## MEMORANDUM

<b>DATE:</b>	June 6, 2014
<b>FROM:</b>	John Sexton
<b>TO:</b>	Cindy Pionke
<b>CC:</b>	Jim Snowden
<b>SUBJECT:</b>	Nubbin Ridge Road driveway sight distance

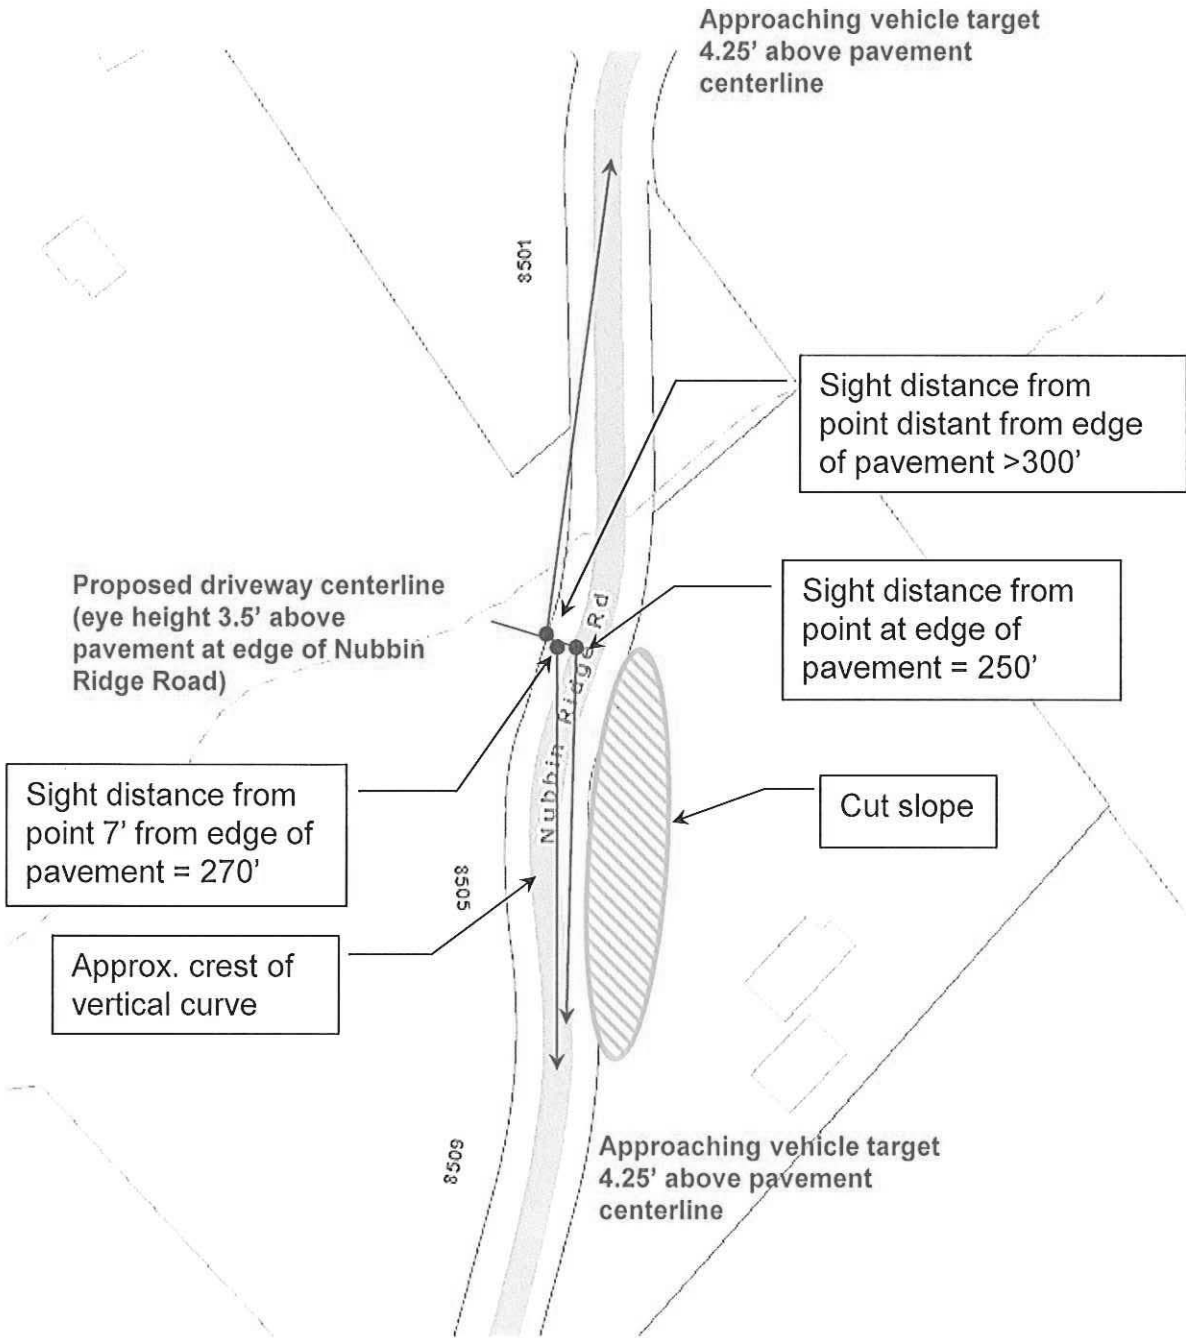
The posted speed limit on Nubbin Ridge Road is 30 MPH, so the required sight distance is 300 feet. I measured sight distance to the left and to the right from the proposed driveway location and have attached a figure and photographs to illustrate my findings. Sight distance to the left is greater than 300 feet at the edge of pavement and is expected to be similar at points along the driveway distant from Nubbin Ridge Road if vegetation is removed and if the driveway elevation is the same as that of the Nubbin Ridge Road edge of pavement.

Sight distance to the right is 250 feet at the edge of pavement and 270 feet at approximately seven feet from the Nubbin Ridge Road edge of pavement. It is possible that slightly greater sight distance may be obtained farther from the edge of pavement, but vegetation and the grade of the side slope at the driveway location did not allow me to verify that possibility.

View from 300' south (right)  
of proposed driveway

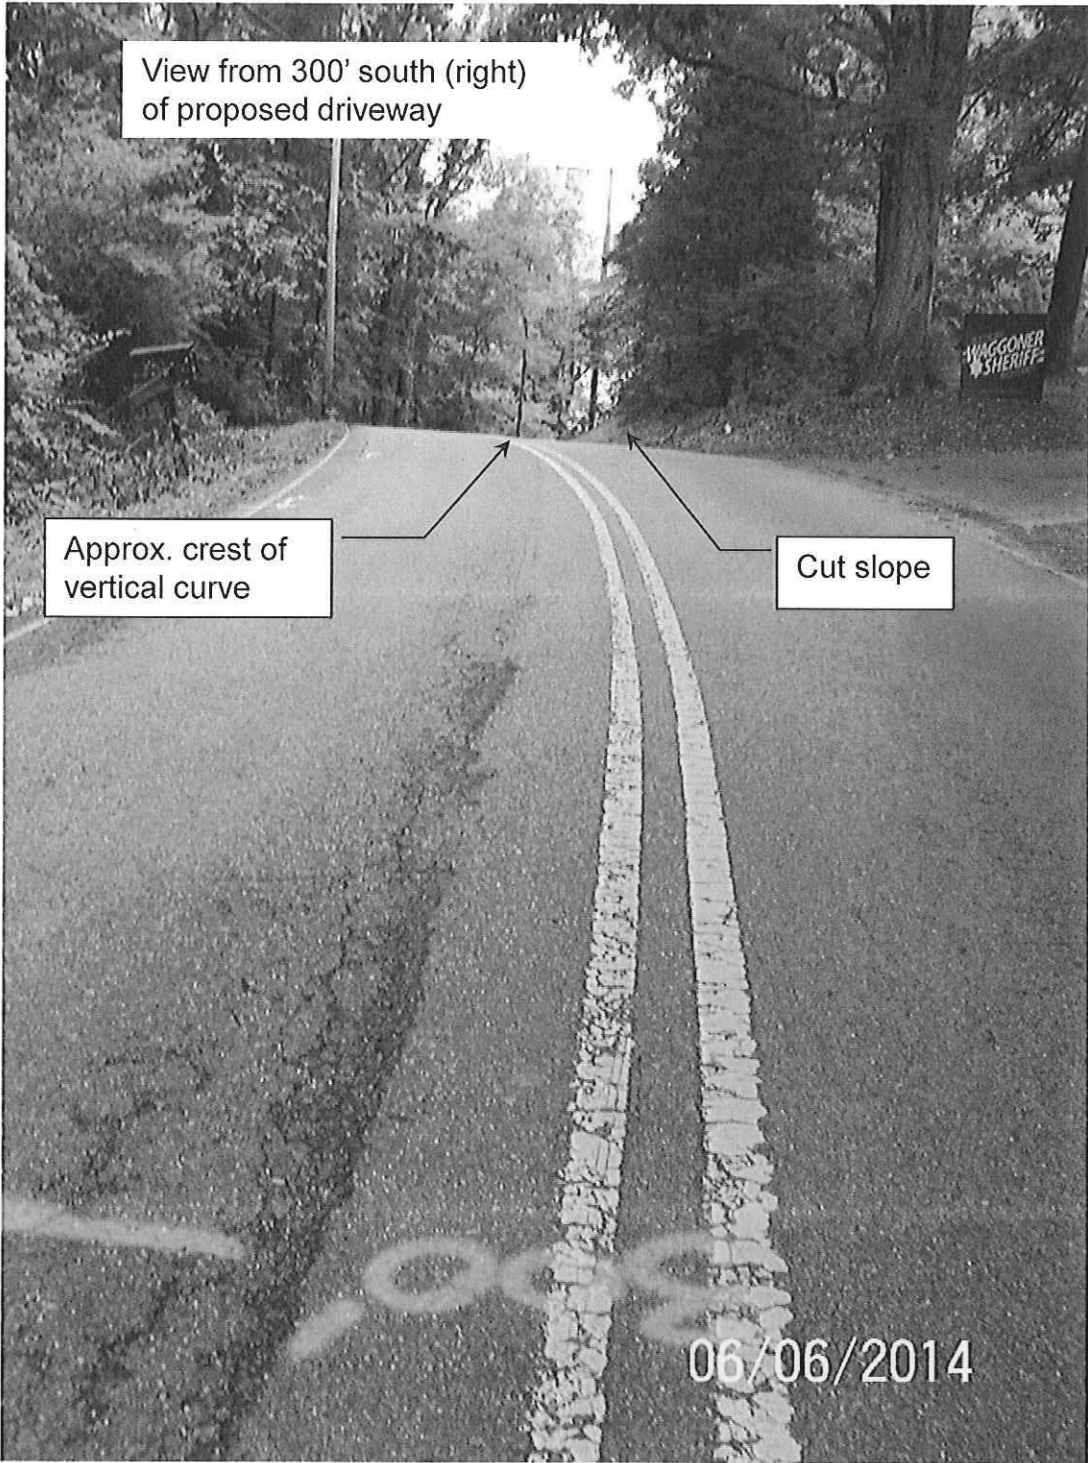
2. There is a cut slope on the east side of Nubbin Ridge Road (the road runs approximately north-south in the vicinity of the driveway) south of the driveway location. The combination of the horizontal alignment of Nubbin Ridge Road and the presence of the cut slope create a condition in which sight distance increases along the proposed driveway centerline farther from the Nubbin Ridge Road edge of pavement. However, this condition also may create a "blind spot" near the Nubbin Ridge Road edge of pavement.

3. There is a crest vertical curve on Nubbin Ridge Road south of the proposed driveway location that appears to restrict sight distance to less than 300 feet from any point along the proposed driveway centerline. As noted, I was not able to verify this due to vegetation and grades.

Approx. crest of  
vertical curve

Cut slope

- Clear vegetation so that sight distance may be fully documented.
- Determine the grade of the proposed driveway within 15 feet of the Nubbin Ridge Road edge of pavement.
- Check the available sight distance along the proposed driveway centerline from the Nubbin Ridge Road edge of pavement to a point 15 feet from the edge of pavement.
- Document the extent of any "blind spots" created by the cut bank on the east side of Nubbin Ridge Road.
- Document whether the crest vertical curve on Nubbin Ridge Road restricts sight distance to the right to less than 300 feet.
